UNITED STATES DEPARTMENT OF THE INTERIOR

Revisions to Operator-Submitted EC Data for Sundry Notice #487154

PECOS DISTRICT DRILLING CONDITIONS OF APPROVAL

OXY USA Inc. - Salt Flat CC 20-29 Federal Com 34H-35H-36H - Amended Drill Plan

Offline Cementing

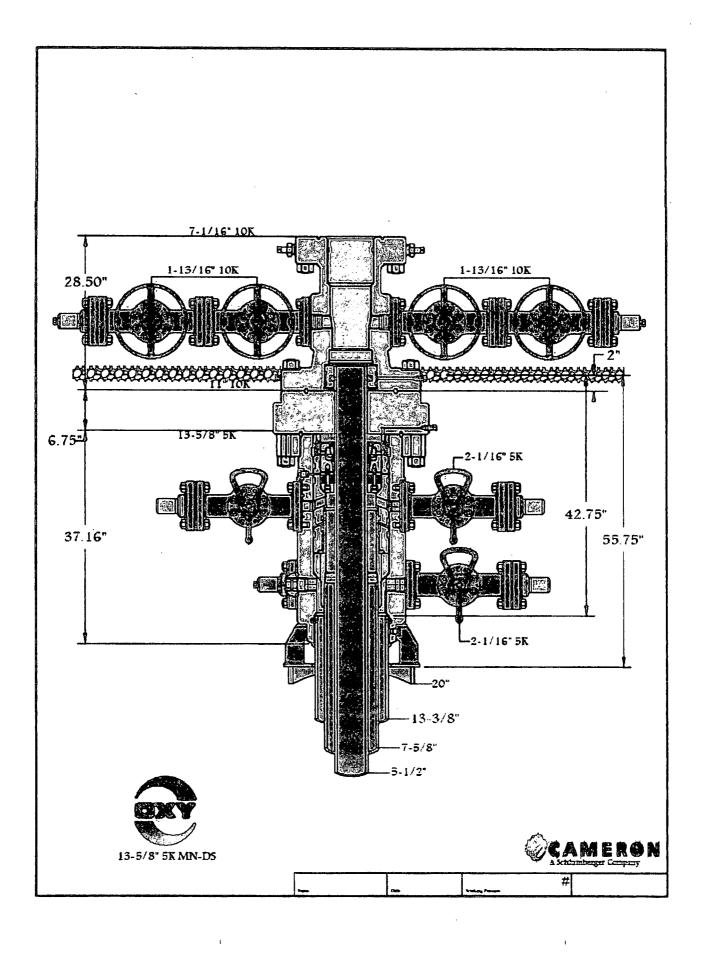
OXY respectfully requests a variance to cement the 9-5/8" and/or 7-5/8" intermediate casing strings offline.

- 1. Run casing as per normal operations. While running casing, conduct negative pressure test and confirm integrity of the float equipment (float collar and shoe).

- 2. Land casing.
- 3. Fill pipe with kill weight fluid, and confirm well is static.
 - a. If well is not static notify BLM and kill well.
 - b. Once well is static notify BLM with intent to proceed with nipple down and offline cementing.

- 4. Set and pressure test annular packoff.
- 5. After confirmation of both annular barriers and internal barriers, nipple down BOP and install cap flange. If any barrier fails to test, the BOP stack will not be nippled down until after the cement job is completed.

- 6. Skid rig to next well on pad.
- 7. Confirm well is static before removing cap flange.
- 8. If well is not static notify BLM and kill well prior to cementing or nippling up for further remediation.

- 9. Install offline cement tool.
- 10. Rig up cement equipment.
 - a. Notify BLM prior to cement job.
- 11. Perform cement job.
- 12. Confirm well is static and floats are holding after cement job.

- 13. Remove cement equipment, offline cement tools and install night cap with pressure gauge for monitoring.

• Contact the BLM prior to the commencement of any offline cementing procedure.

General well schematic:

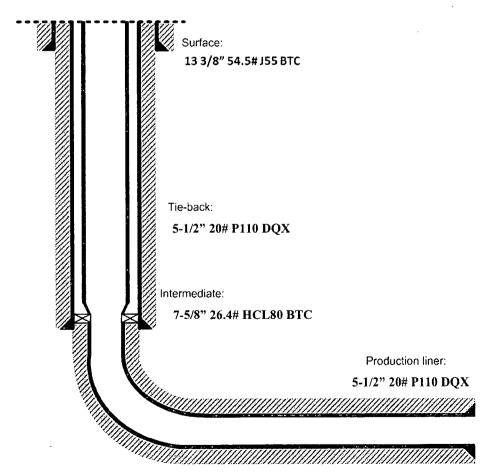
- Drill 17-1/2" hole x 13-3/8" casing for surface section. Cement to surface.
- Drill 9-7/8" hole x 7-5/8" casing for intermediate section. Cement to surface.
- Drill 6-3/4" hole x 5-1/2" liner for production section. Cement to top of liner, 100' inside 7-5/8" shoe.
- Release drilling rig from location.
- Move in workover rig and run a 5-1/2" 20# P110 DQX tie-back frack string and seal assembly (see connection specs below). Tie into liner hanger Polished Bore Receptacle (PBR) with seal assembly.
- Pump hydraulic fracture job.
- Flowback and produce well.

When a decision is made to develop a secondary bench from this wellbore, a workover rig will be moved to location. The workover rig will then retrieve the tie-back frack string and seal assembly before temporarily abandoning the initial lateral.
